Office Action Summary	Application No.	Applicant(s)	
	10/630,731	YOSHIZAWA, TAKENORI	
	Examiner	Art Unit	
	Alfred Joseph Wujciak III	3632

This is the non-final Office Action for the serial number 10/630,731, DISPLAY SUBSTRATE ACCOMMODATING TRAY AND APPARATUS AND METHOD FOR REMOVING THE DISPLAY SUBSTRATE, filed on 7/31/03.

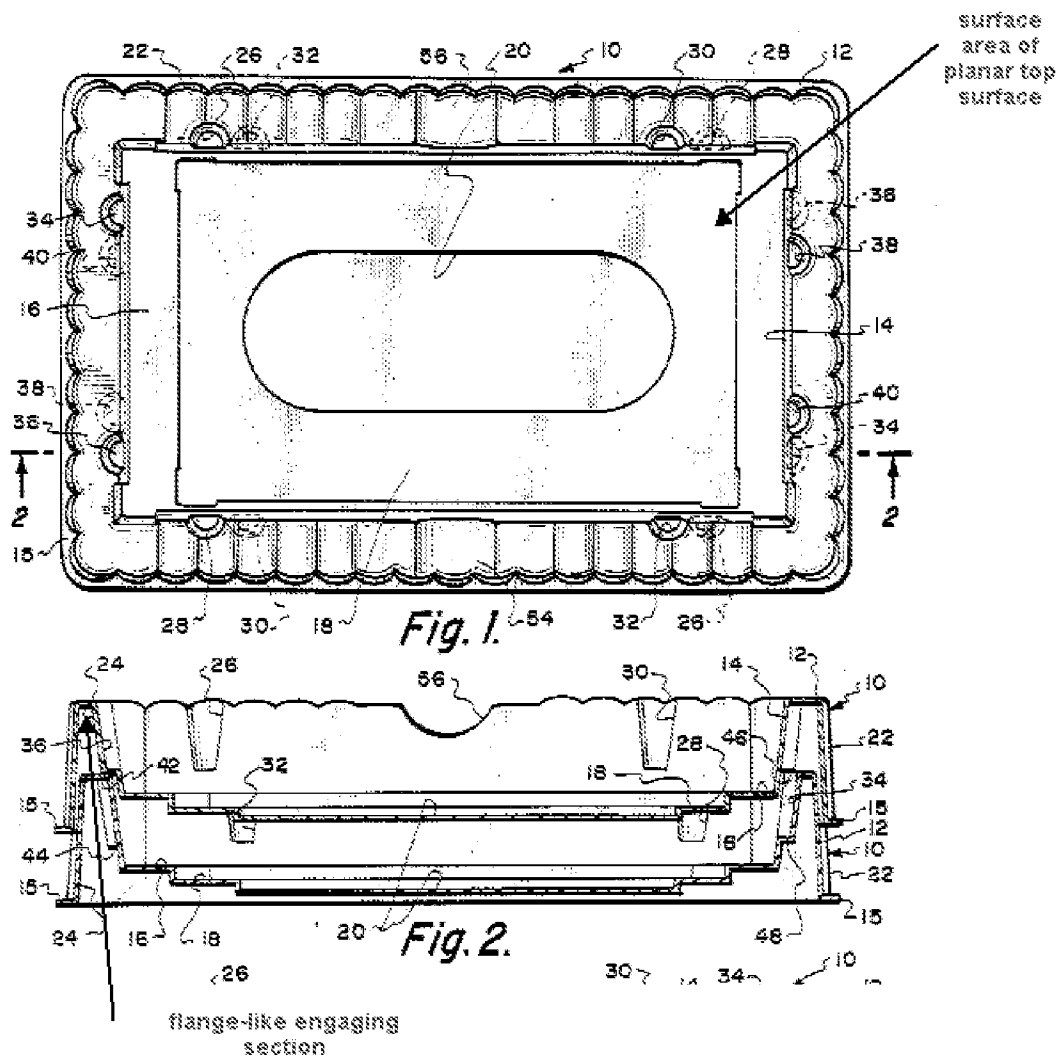
Vartanian teaches a tray comprising a bottom section (20) supports a display substrate (video tape, column 2, lines 23-27) on at least a portion of a planar top surface (18) of the bottom section in a vicinity of the center of the display substrate, wherein the display substrate contacts at least a portion of the bottom section in the vicinity of the center of the display substrate. The tray includes a frame (16) provided along a periphery of the bottom section and the frame projects to a level higher than a level of the top surface of the bottom section. The tray includes a flange-like engaging section (42) protruding externally from walls of the frame in a substantially horizontal fashion. The frame has a planar top surface and the flange having a wall (between the flange and frame) defining an inner periphery thereof to define a positional relationship (see figure 2). The planar top surface of the frame is parallel to the planar top surface of the bottom section having the display substrate and the wall of the flange-like is

connected to the planar surface of the frame. The wall of the flange-like projects a level higher than the level of the planar top surface of the frame with respect to the surface of the bottom section. Wherein the portion of the planar top surface supporting the display substrate has a surface area that is at least majority of the surface area of the bottom surface of the display substrate. The flange-like engaging section having a horizontal gap (see diagram below in this office action) below the flange-like engaging section.

Vartanian teaches the width of the frame but fails to teach the width of the frame is substantially larger than the distance between the top of the top surface of the frame and the top surface of the bottom section. It would have been obvious for one of ordinary skill in the art at the time the invention was made to have modified the width of the frame to be larger than the distance between the top of the top surface of the frame and the top surface of the bottom section to provide a larger surface area for supporting a smaller size of video tape (column 2, lines 26-27).
